POST OFFICE BOX 61
PETALUMA, CA 94953-0061
ADDENDUM NO. 4

PETALUMA TURNING BASIN FLOATING DOCK City Project Number C14402010

March 21, 2023

- P1 - PLAN VIEW & PROFILE VIEW
- P2 - GANGWAY SHOP DRAWINGS
- P3 - SECURITY GATE SHOP DRAWINGS

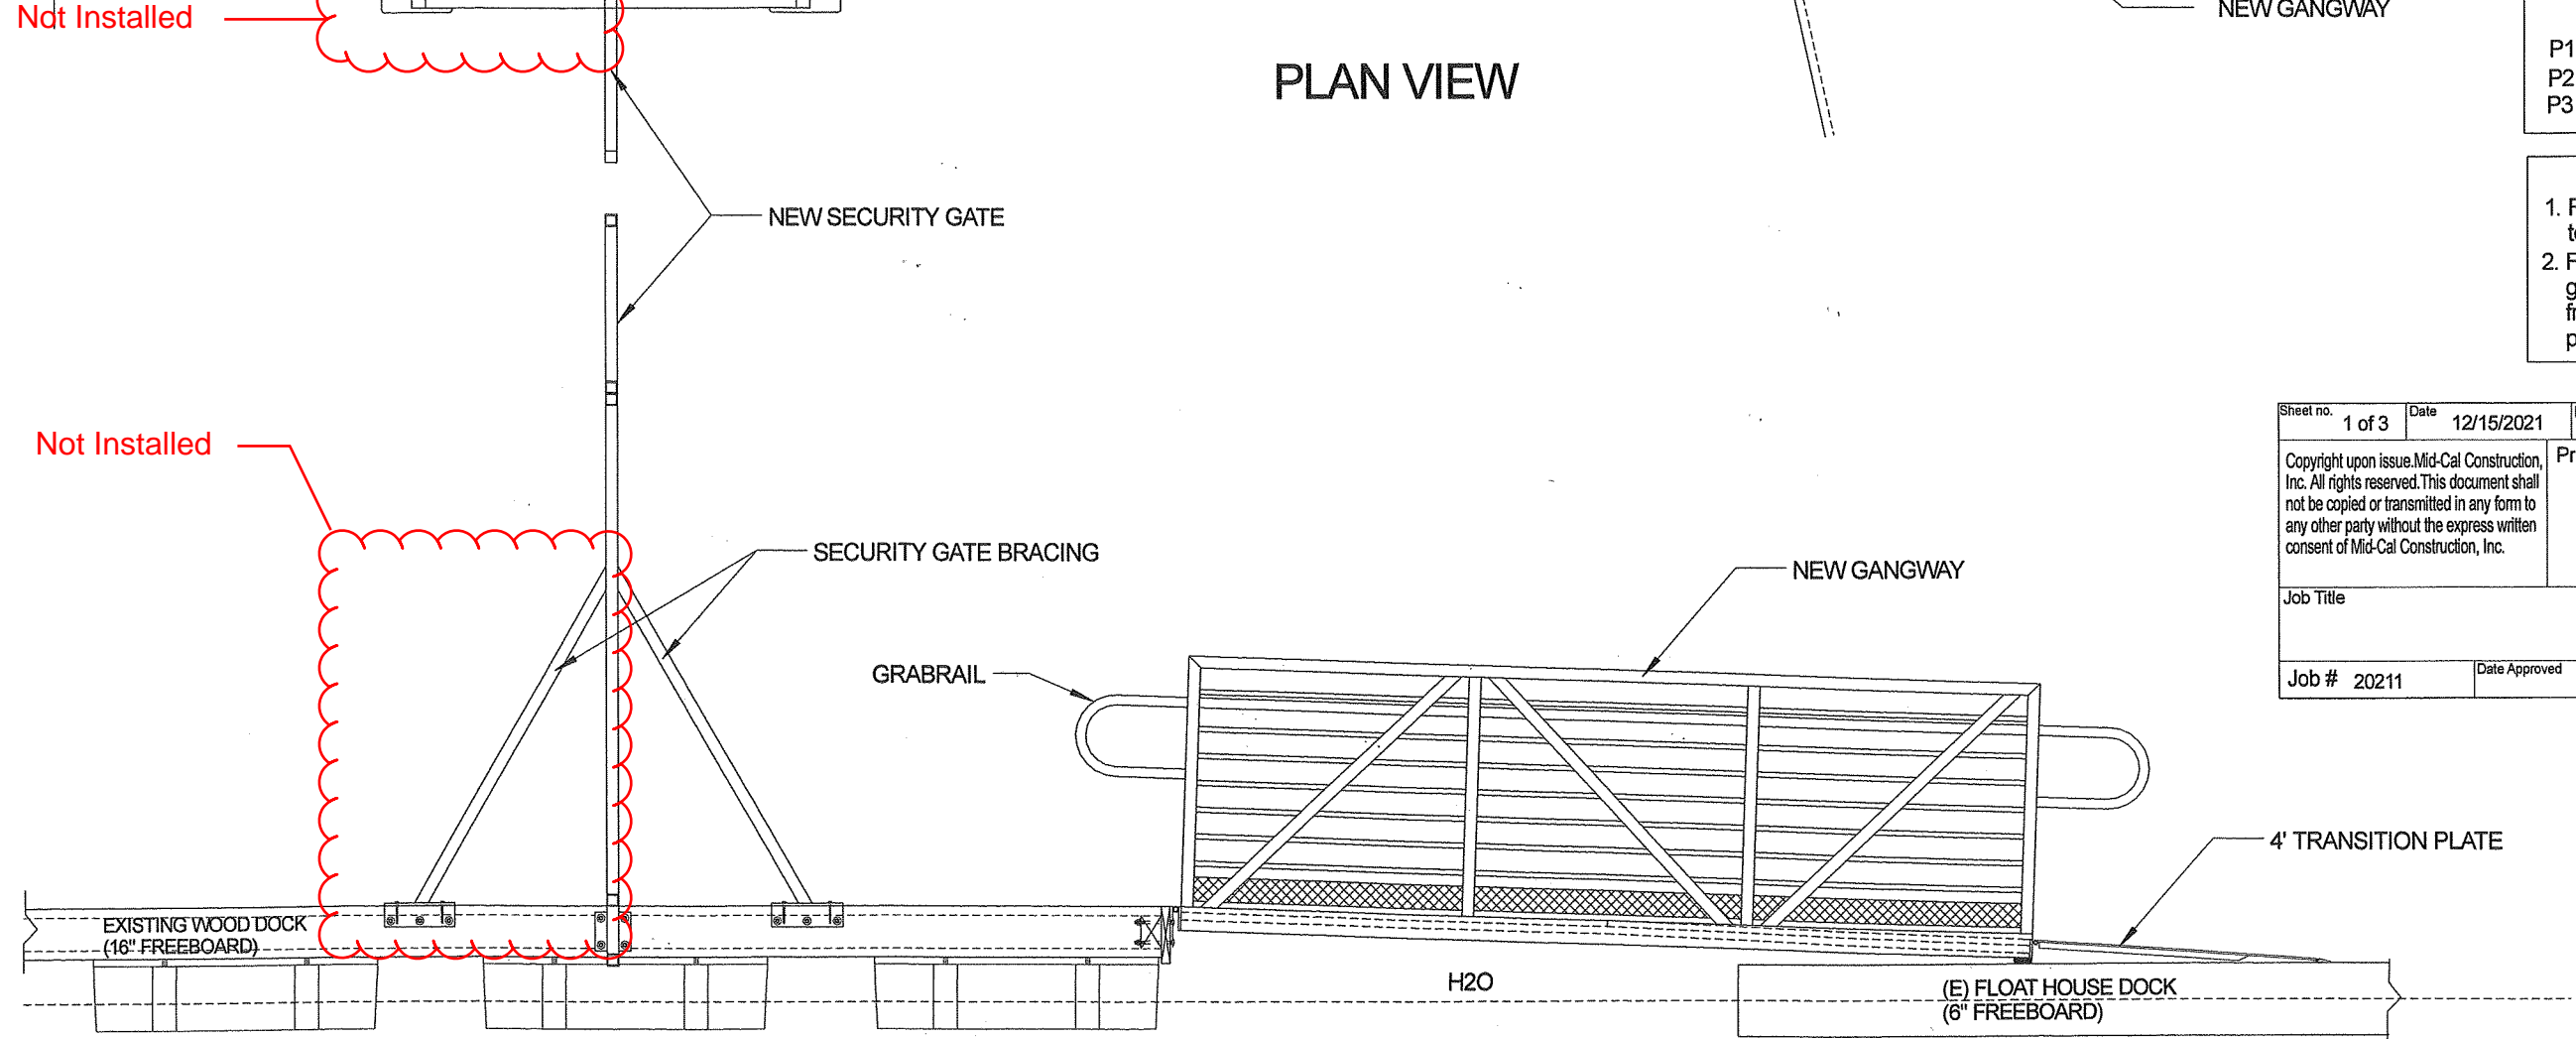
Q: Will the city provide us with the Gangway and Security Gate shop drawings?

A: Please see attached.
